AGENDA

Planning Committee Meeting to be held at Darebin Civic Centre, 350 High Street Preston on Tuesday 14 March 2023 at 6.30pm.

5.1 APPLICATION FOR PLANNING PERMIT PA2201557

Property:	57 - 59 Showers Street, Preston		
References:	Department of Transport and Planning (DTP) Reference: Planning Application PA2201557		
	Council Reference: PIR/274/2022.		
Proposal:	The construction of an eight (8) storey social housing development comprising 32 apartments and a reduction in the statutory car parking requirement.		
Application Type:	This is a planning permit application being considered by the Minister for Planning that has been informally referred to Council for comment (as the Minister for Planning is the Responsible Authority pursuant to Clause 72.01 of the Darebin Planning Scheme). It has been submitted on behalf of the Department of Health and Human Services (DHHS) for the purpose of 100 per cent social housing (32 dwellings).		
Zoning and Overlay/s:	 Mixed Use Zone – Schedule 1 (MUZ1) Development Plan Overlay - Schedule 11 (DPO11) Development Contributions Plan Overlay – Schedule 1 (DCPO1) Environmental Audit Overlay (EAO) Special Building Overlay (SBO)

Figure 5 – Proposed linkages through the precinct

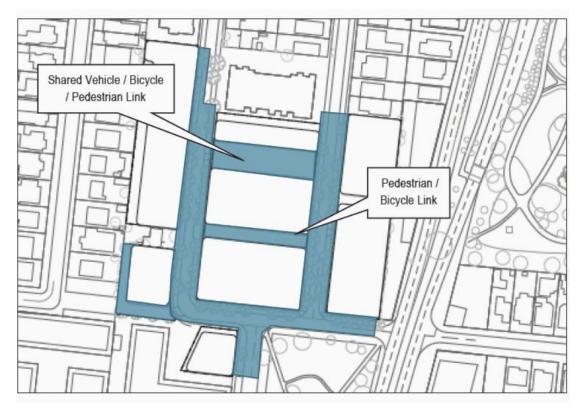
In regard to precinct wide connectivity, Figure 5 below illustrates where the subject site will benefit from an enhanced east-west pedestrian / cycle laneway between Stokes Street and Penola Street:

Again, a condition of approval recommending public infrastructure upgrades, including enhance landscape outcomes will ensure improved connectivity and an enhanced pedestrian experience.

Figure 7 – Proposed ground floor plan showing the location proposed tree planting locations (Source: Hayball Architects dated 29 November 2022).

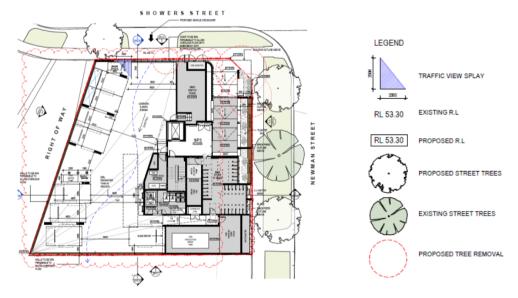
The proposal provides limited on-site landscaping, particularly in relation to deep-soil planting and landscaping at the podium level. To address this, conditions are recommended to achieve compliance requirements of Clause 58, including on deep-soil planting and landscaping at the podium level (with the latter being a key landscaping objective of the Development Plan). Recommended conditions will also include the satisfactory treatment of footpaths with the incorporation of landscape zones along the northern, western and eastern elevations of the development.

Figure 12 - Required articulation to achieve equitable development

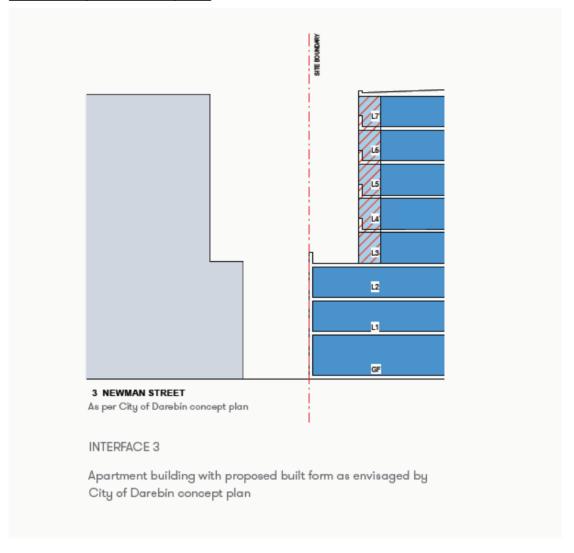
Having regard to the above, the proposal appropriately incorporates the required three-storey street wall and subsequent upper-level setback at its Newman Street frontage.
